**Proposal #21: 8997-00-40**  
**C Rice Lake, South Main Street**  
**Red Cedar River Bridge B030002**  
**Local Street**  
**Barron County**

This is Addendum No. 02, which provides for the following:

**ADDENDUM NO. 02**

**8997-00-40**

Addendum No. 02  
 ID 8997-00-40  
 Revised Sheet 47  
 April 2, 2018

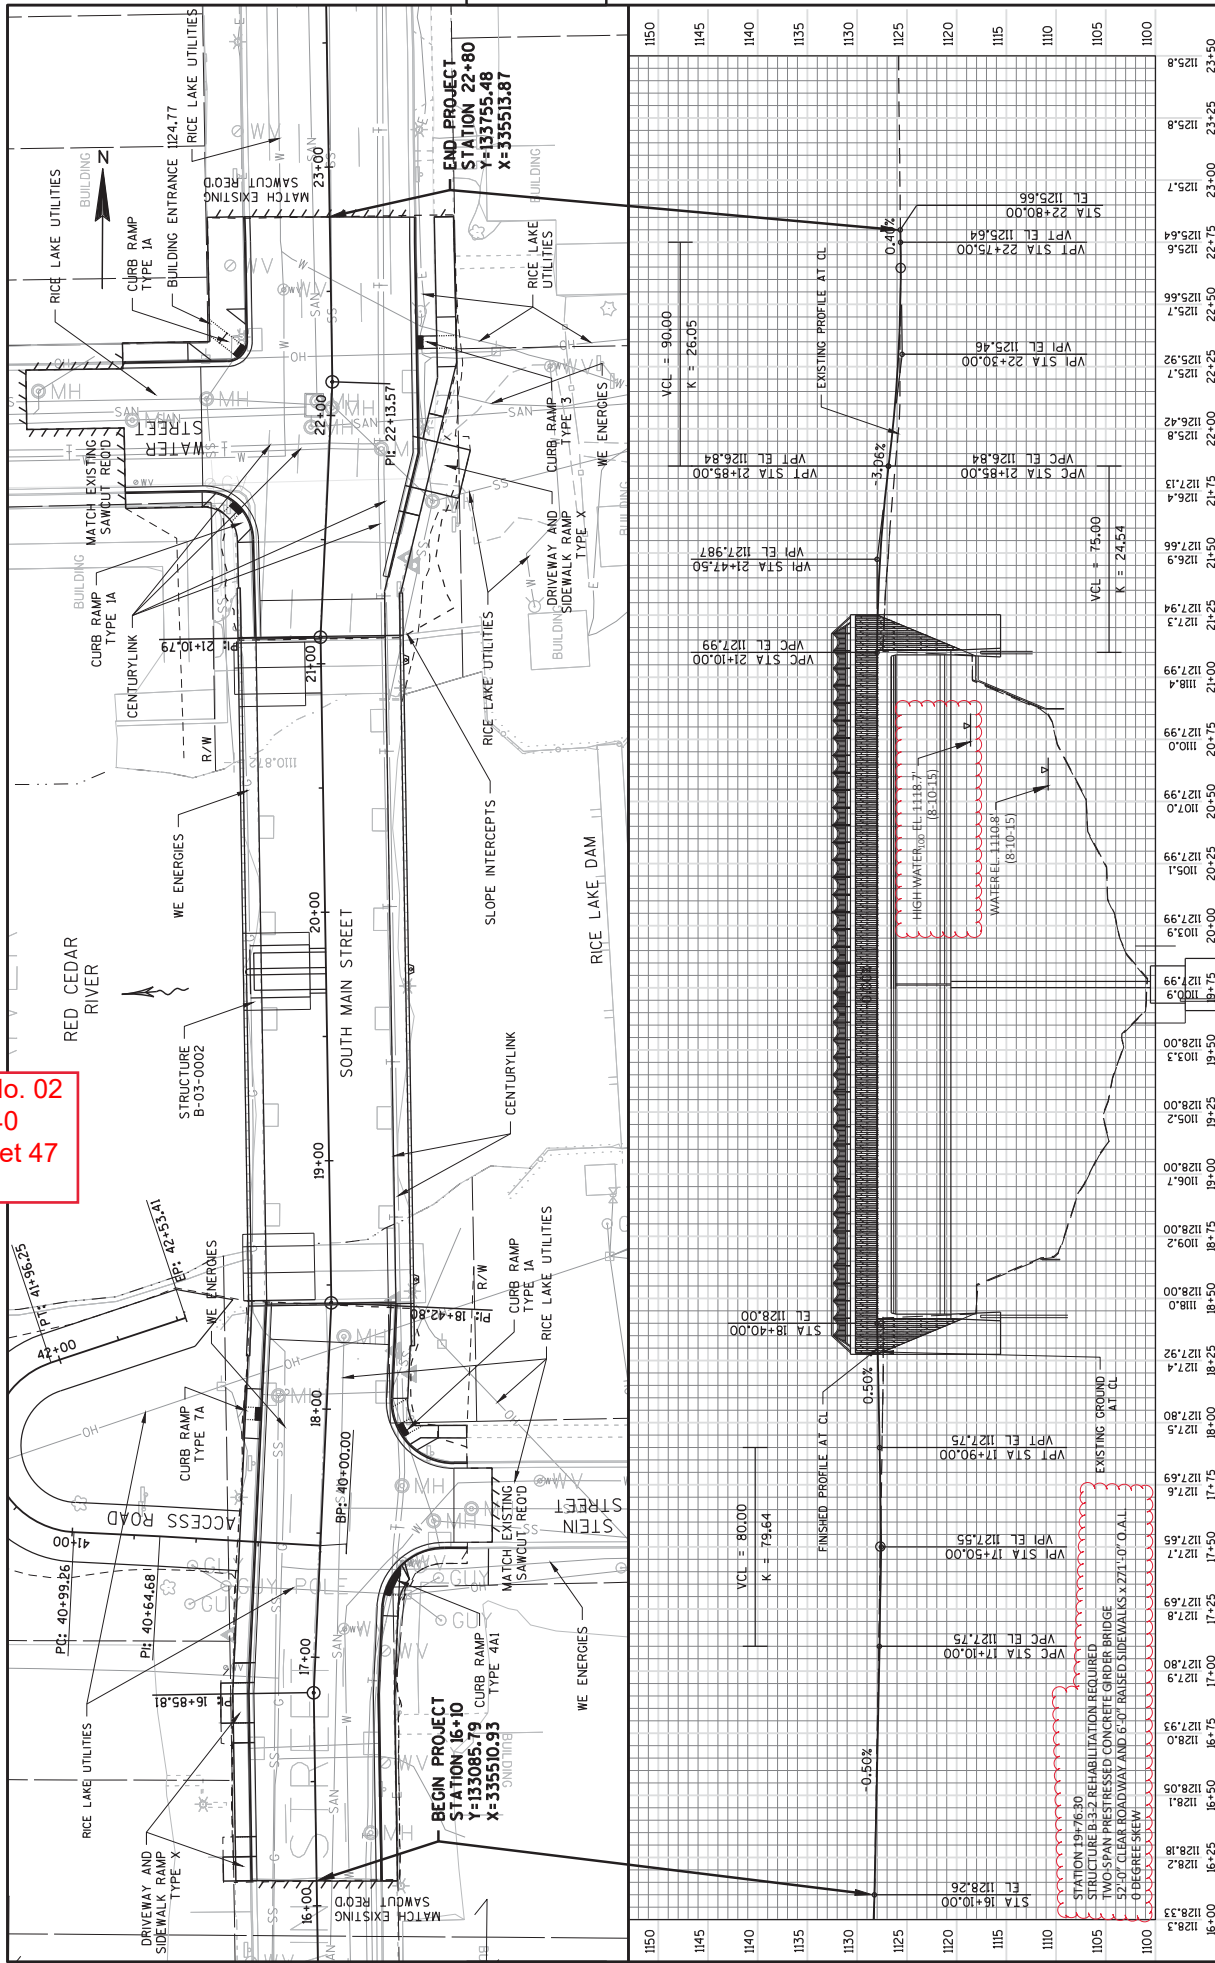
<b>Revised Plan Sheets</b>	
<b>Plan Sheet</b>	<b>Plan Sheet Title (brief description of changes to sheet)</b>
47	Plan and Profile: Main St (corrected highwater elevation and text in description of structure work)

The following 8½ x 11-inch sheets are attached and made part of the plans for this proposal:  
Revised: 47
